AGENDA
FARRAGUT MUNICIPAL PLANNING COMMISSION

July 20, 2017
7:00 p.m. Farragut Town Hall

SUBJECT: Discussion and public hearing on a resubdivision plat involving the Y-12 Federal Credit Union property at 13128 Kingston Pike, 5.3 Acres, Zoned C-1 (Daniel Humphreys, Applicant)

SUBJECT: Discussion and public hearing on a site plan for an addition to the Farragut ENT building at 144 Concord Road, 1.4 Acres, Zoned C-1 (Urban Engineering, Applicant)

CONCEPT PLAN
CREEKSIDE ESTATES
PLACEMAKERS PARTNERSHIP — FARRAGUT, TN.

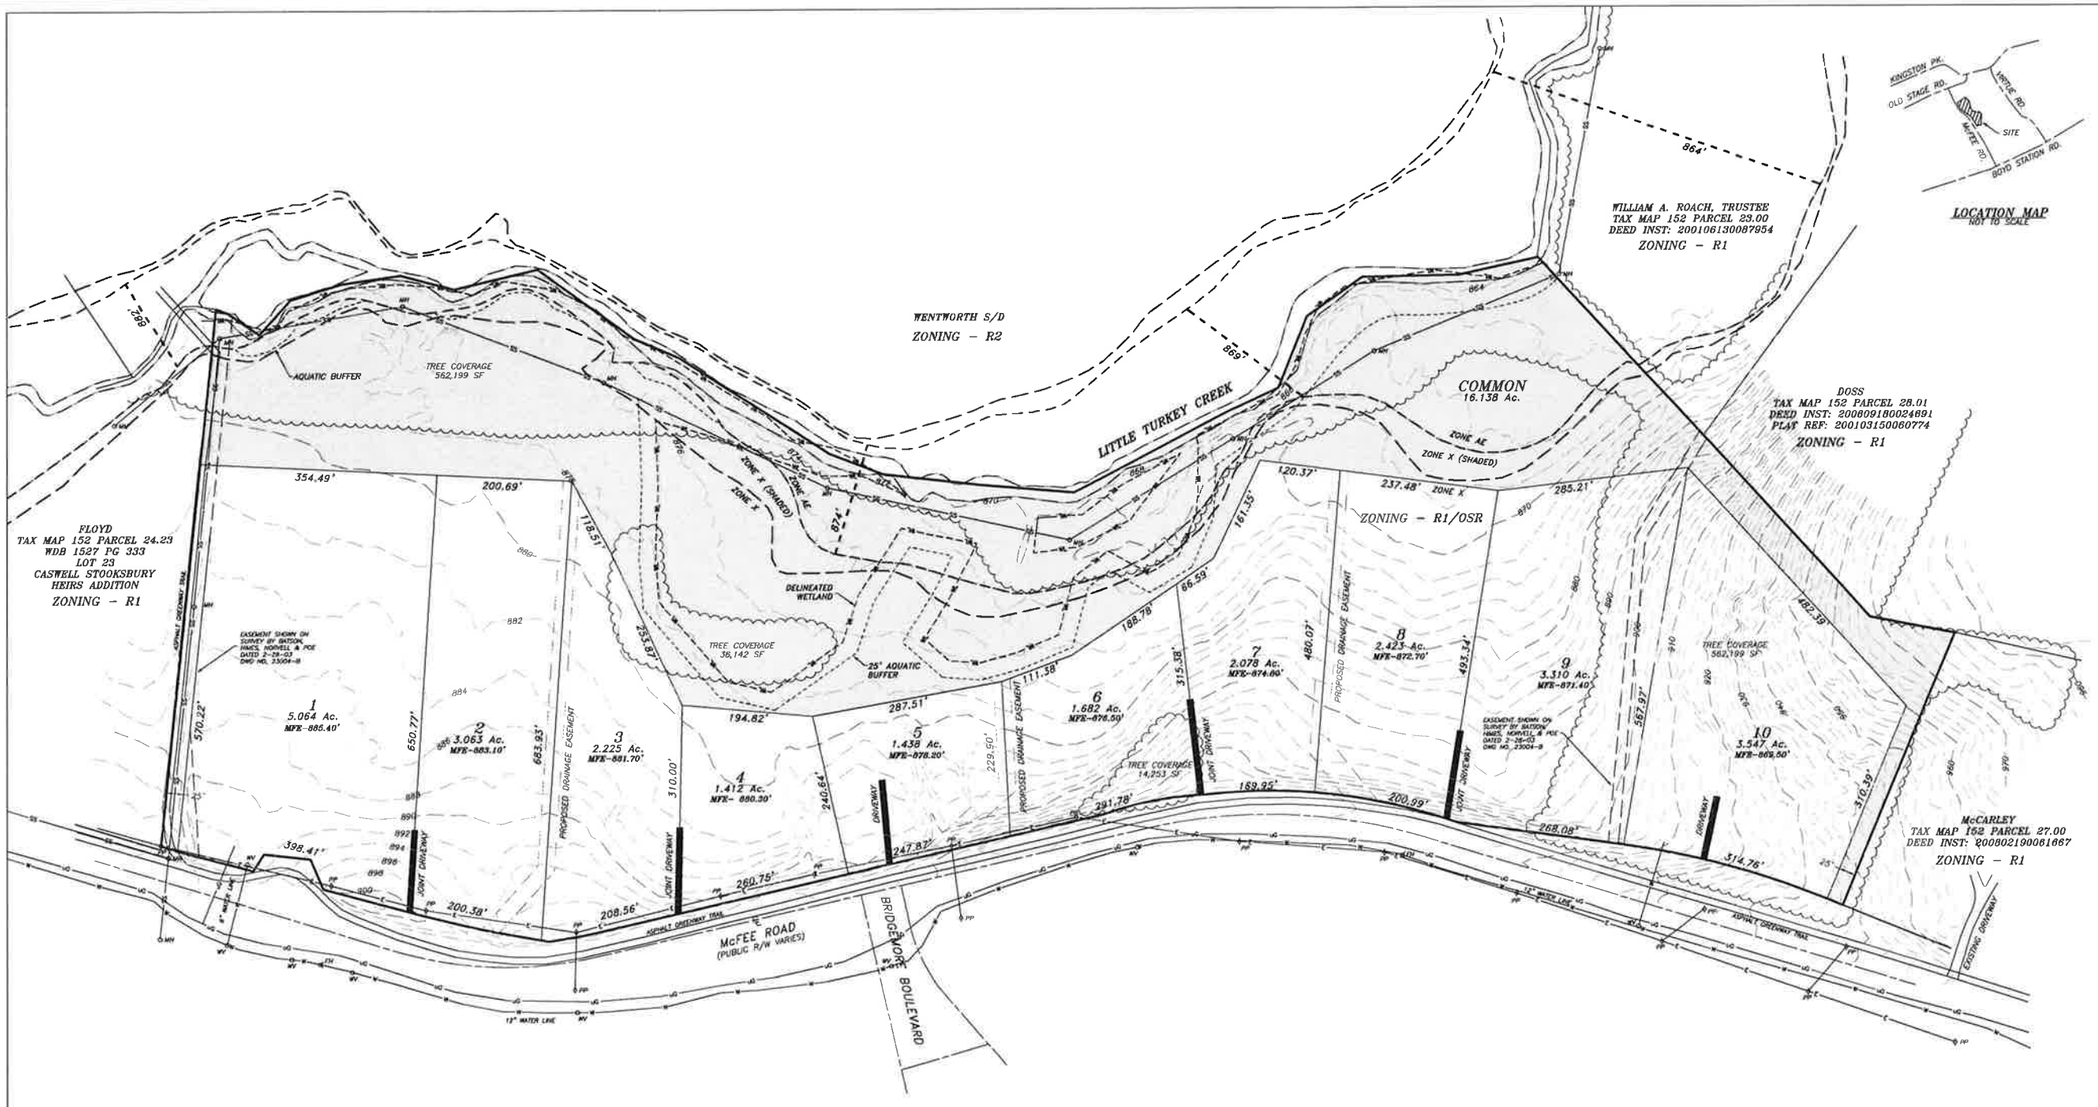
1. Based on the data provided, additional fire hydrants will be required along McFee Road; This will be coordinated with Dan Johnson during platted process and additional hydrants will be added as necessary.

2. The property included in this concept plan is still included with the concept plan for the Bridgemore Subdivision. The Bridgemore Subdivision concept plan will need to be updated to omit (if that is correct) this area from the concept plan. The revised plan must demonstrate that the land on the west side of McFee Road which would now include all of Bridgemore, can and will meet all requirements of the R-1/OSR. For example, the land on the west side of McFee Road must contain at least 35% open space. This and other calculations, lot numbering, etc., will need to be updated accordingly; Billy Fulghum will be revising the concept plan for Bridgemore for his next submittal.

5. Please show the existing accesses on both sides of McFee Road so as to demonstrate compliance with the 400 foot spacing required for an arterial street. This would also include the McCarley access to the south; Entrances shown on plan.

6. MFE's will be required for these lots; MFE's provided on plan
7. Are there any sinkholes on these parcels? If so, please identify and ensure that all aspects of the sinkhole ordinance will be satisfied; There have been no sinkholes identified on the property.

10. Please note that the property is zoned R-1/OSR; Zoning noted on plan.
11. Please show and label the extent of any aquatic buffer and include the note required for aquatic buffers and that is on the Concept Plan checklist; Delineated wetlands and corresponding aquatic buffer shown on plans.

12. Please note the approximate density, predominant species, general distribution of predominant species, and predominant level of maturity of trees within all tree covered areas; Acreage of tree areas provided on plans; however, the intent it not to disturb these areas.

13. Please include the name of the developer; Developer information shown on plan.
14. A preliminary plat will be required for any new stormwater detention, grading, utility extensions – if any, and detention basin access (which may also serve as a walking trail to access open space and platted accordingly – as an amenity is needed for the open space portion of the development). Required improvements will need to be completed prior to the submittal of a final plat. The final plat would need to reflect the as-constructed improvements for purposes of platting easements for stormwater and access/walking trail; Improvements to be constructed prior to submittal of the final plat.

15. Please list those utilities which are readily available and are expected to serve the development; Utility providers listed on the plan.

16. The name of the subdivision ("McFee Manor") has been used by a prior development in the Town and will need to be changed; Name changed to Creekside Estates
17. Where is detention to be located? How will it be accessed for maintenance? Has existing detention in the Bridgemore Subdivision already taken this development into account? If so, please provide written analysis and modify the applicable information for Bridgemore and the covenants for Bridgemore. If detention has not been accounted for then it will need to be addressed as part of a preliminary plat and will need to be constructed along with any other required improvements prior to final plat submittal. Detention requirements will be coordinated with Darryl Smith. Detention will most likely not be necessary/required for these lots.
